# NORTHEAST UTILITIES

February 22, 1983  
Docket No. 50-336  
B10698

Millstone Nuclear Power Station, Unit No. 2  
Request for Additional Information, Measurement Uncertainties  
Response to Question 4

REQUEST FOR ADDITIONAL INFORMATION  
NORTHEAST NUCLEAR ENERGY COMPANY  
MILLSTONE NUCLEAR POWER STATION, UNIT NO. 2  
DOCKET 50-336

FIGURE 3

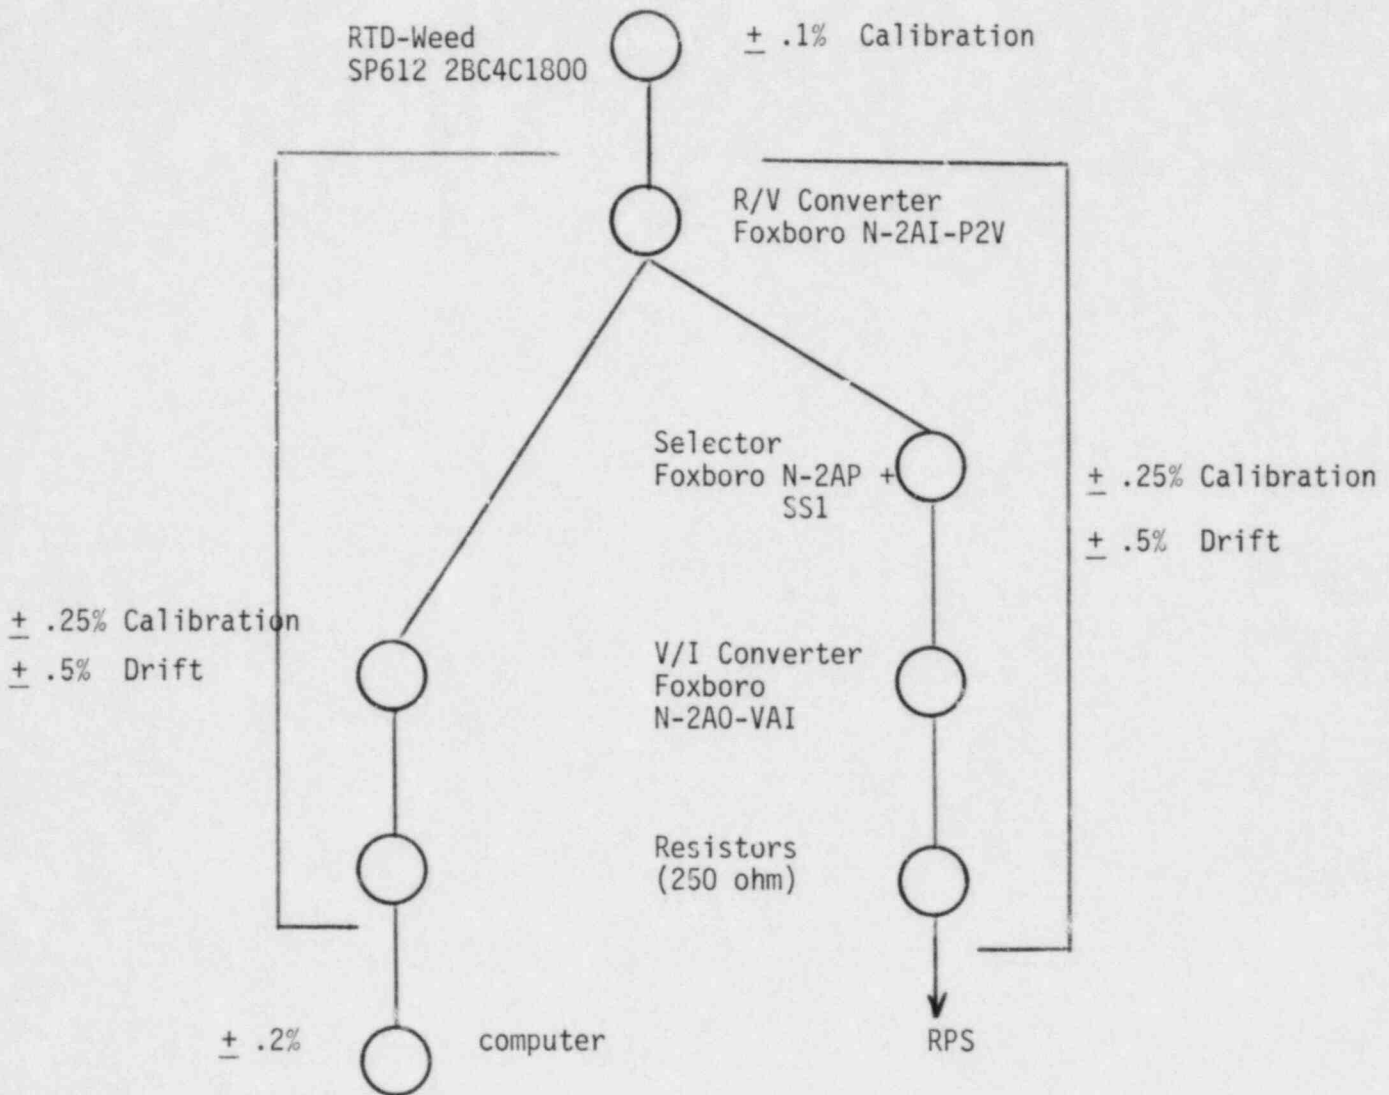
Information is supplied in Appendix A to define instrument span drifts between calibrations. The data supplied are too few to support the assumption of  $2\sigma$  limit. Provide further historical data to confirm the  $2\sigma$  assumption.

Figures 3 and 4 provide the block diagrams for the new primary temperature measurement channels. The primary sensor is a platinum RTD provided by the Weed Instrument Co. The Foxboro SPEC 200 process equipment consists of platinum resistance to voltage (R/V), and V/I converter rack modules. The processed current signal is converted to a voltage signal across a precision 250 ohm resistor which is then provided to either the RPS or to the computer for the primary flow calculation.
